Bolivia Hill upgrade REF submissions report

Bolivia Hill upgrade REF submissions report

February 2016

RMS 16.108

Figure 1-2i: The proposed New England Highway upgrade at Bolivia Hill - Chainage 56800 to 57450

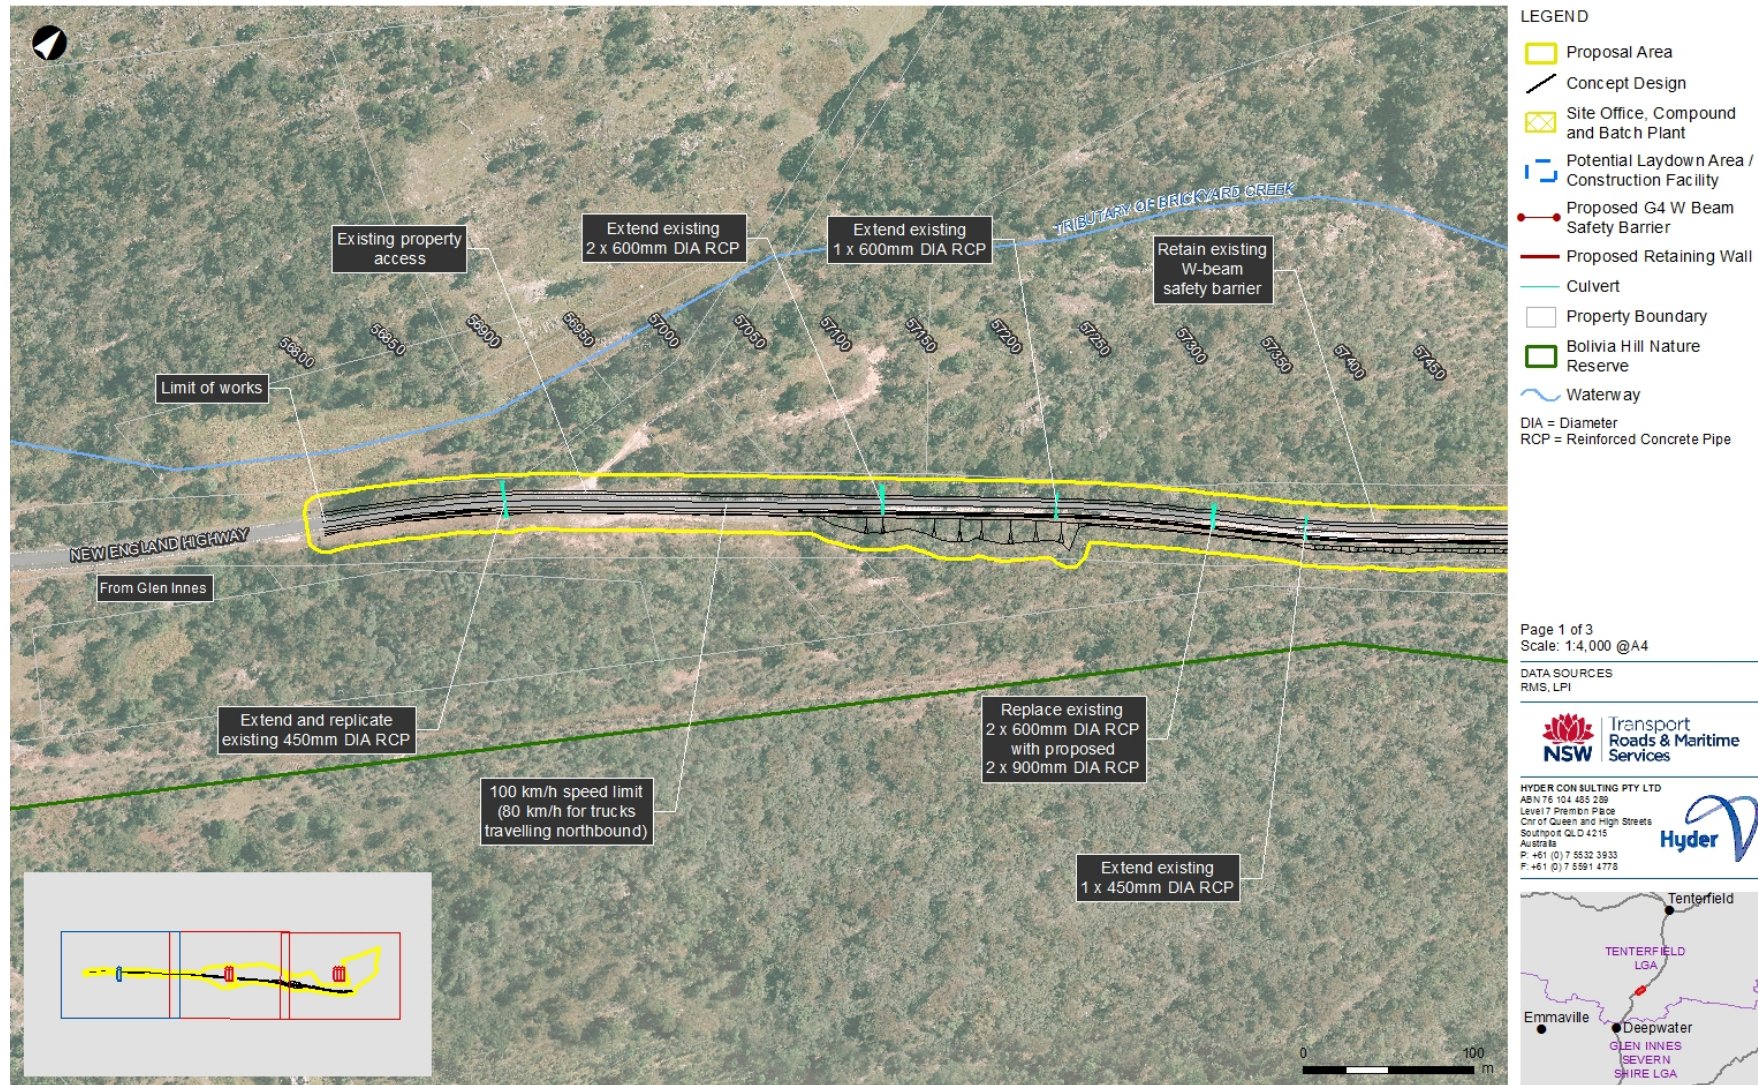
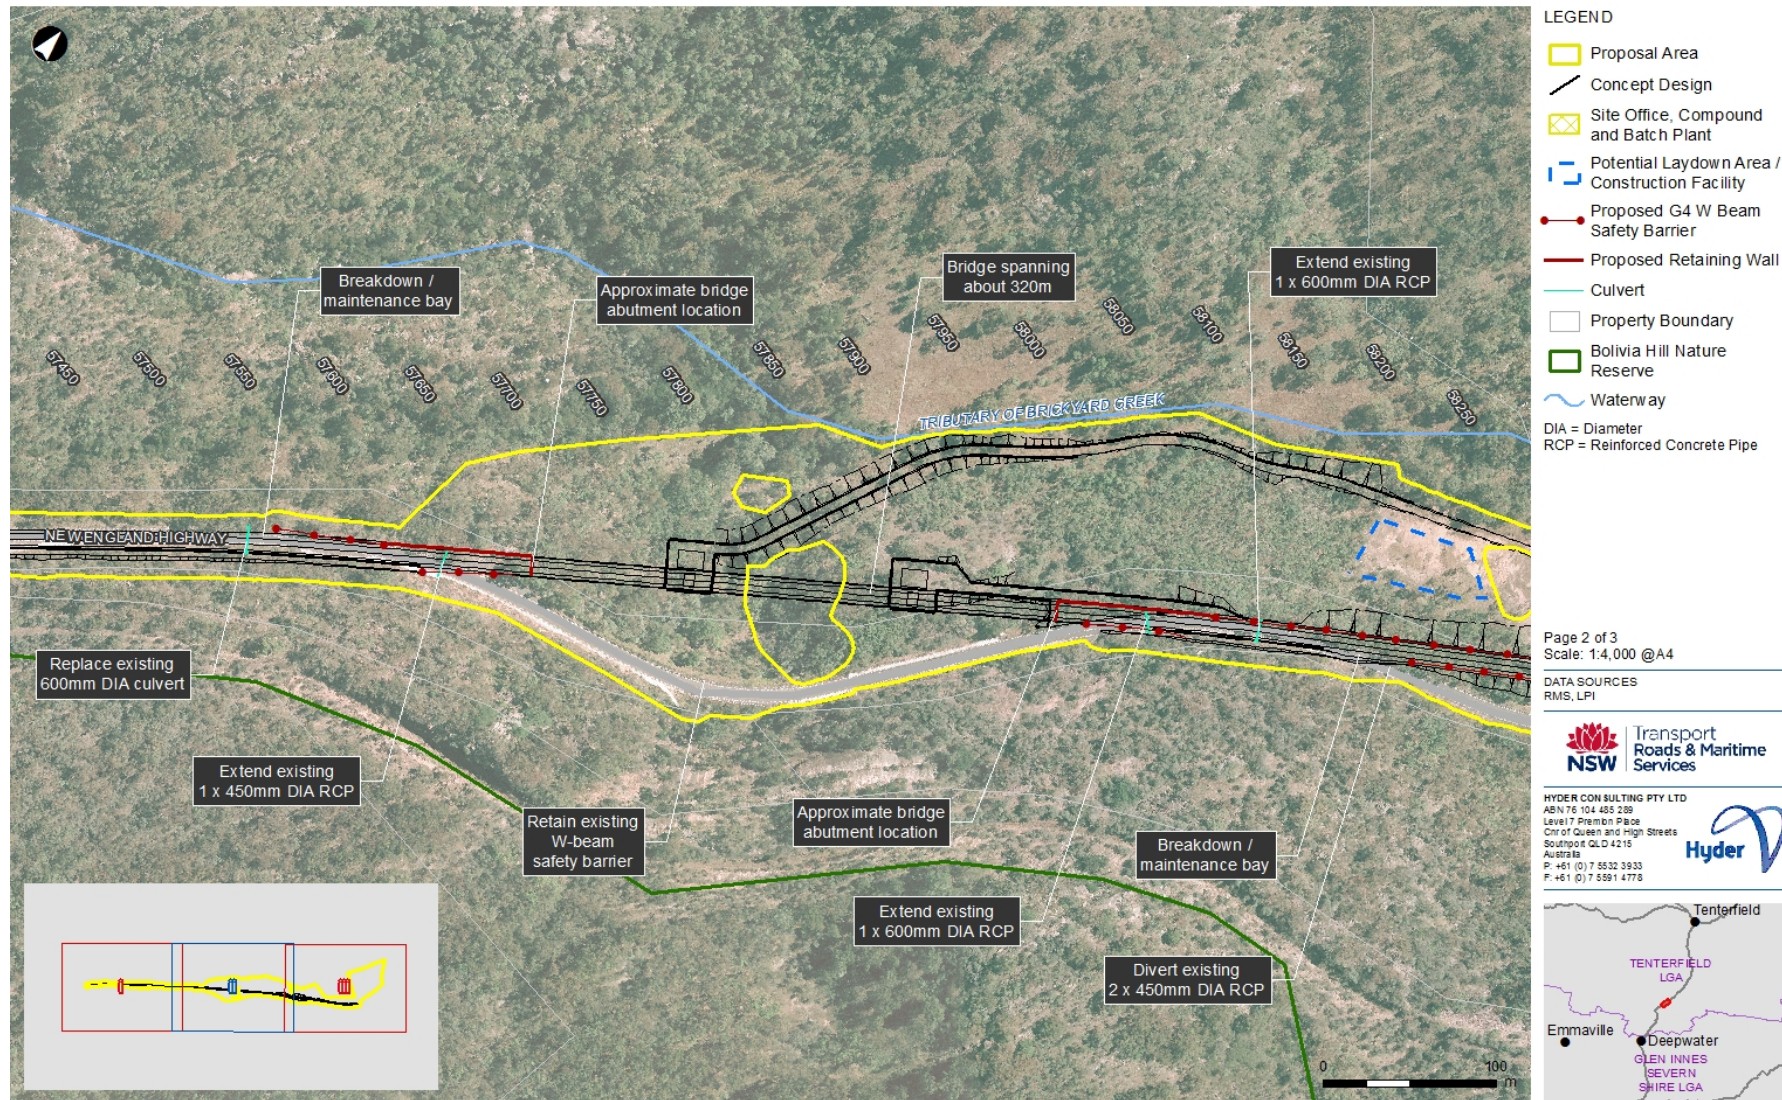
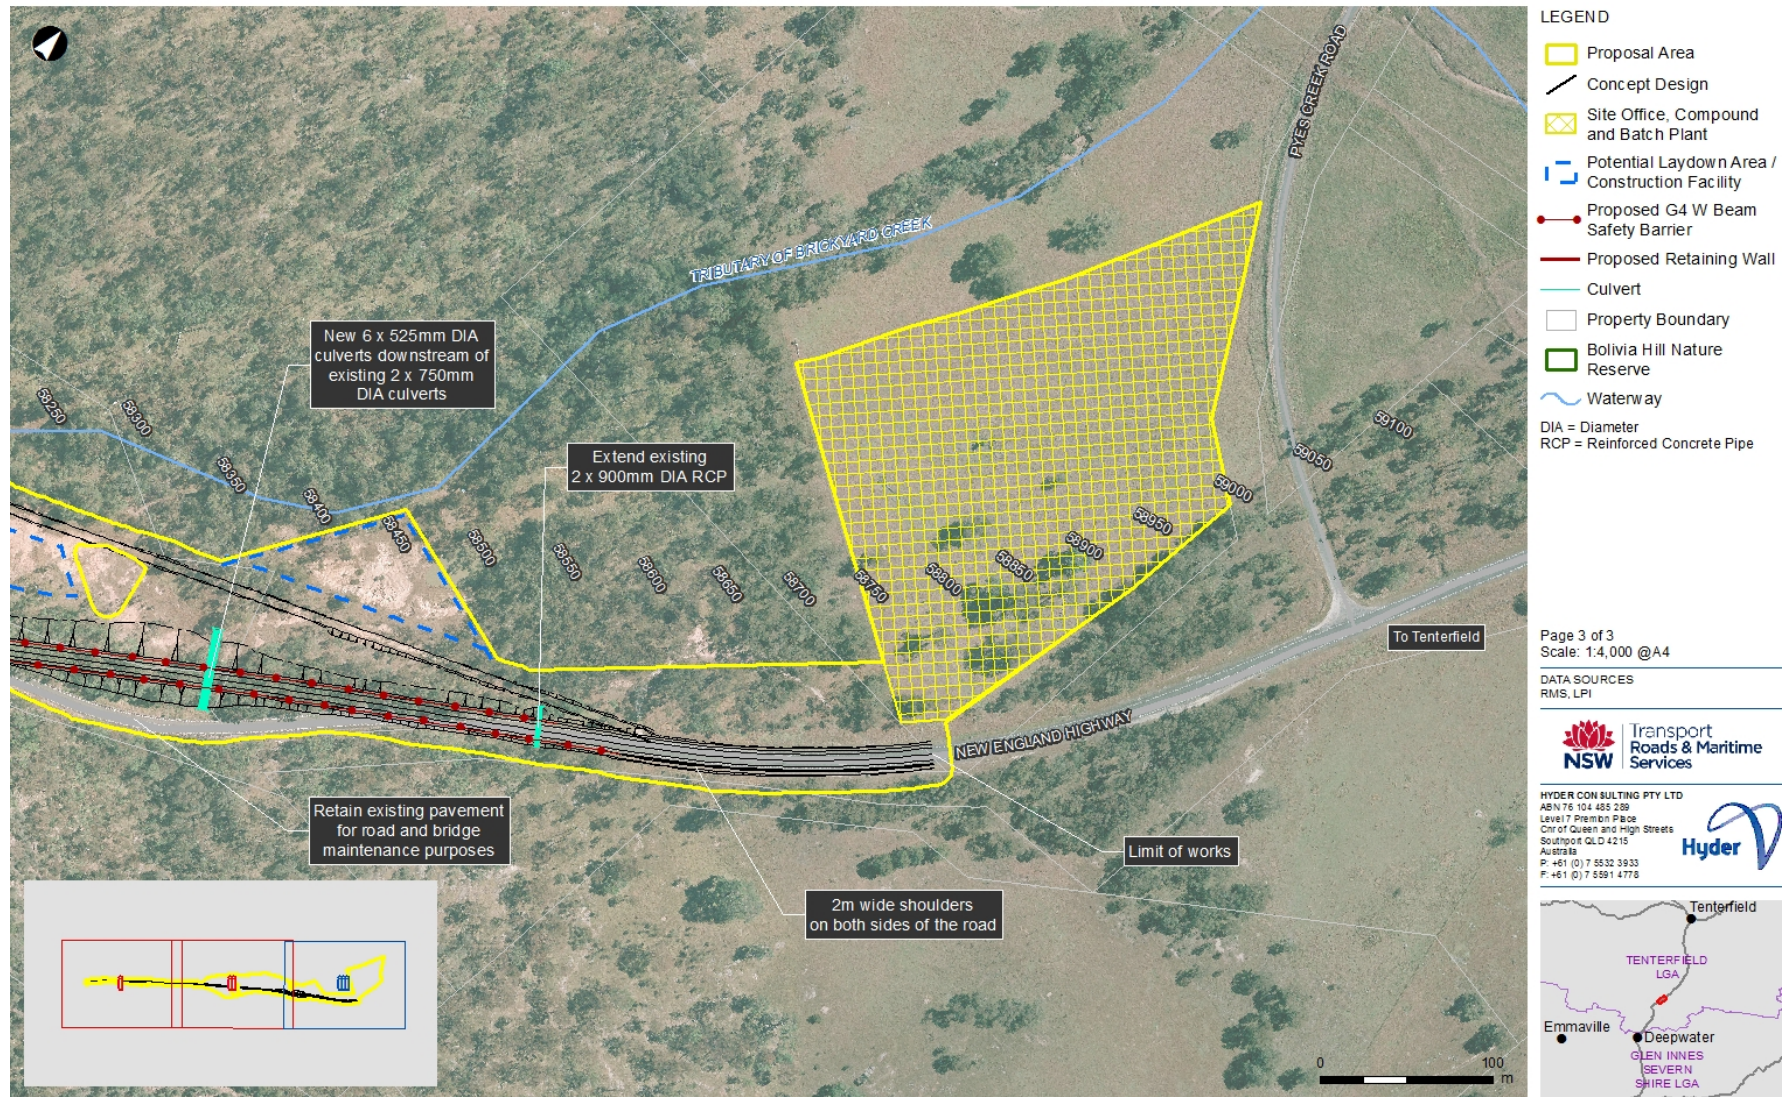
- A larger buffer zone is added around the northern margin of site Bolivia Hill AS1
- The proposed northern compound location boundary is refined to avoid impact to PAD 2

As a result of the recommendations made in the Aboriginal heritage assessment the proposal project boundaries have been altered. A larger buffer zone has been added around the northern margin of site Bolivia Hill AS1. The western boundary of the compound area has been moved east to allow for a buffer area around PAD2. The proposal project boundary next to PAD4 has also been moved to the south to allow a buffer zone around PAD4. The amended Figure 1.2 below indicates the changes to the proposal project area boundaries.
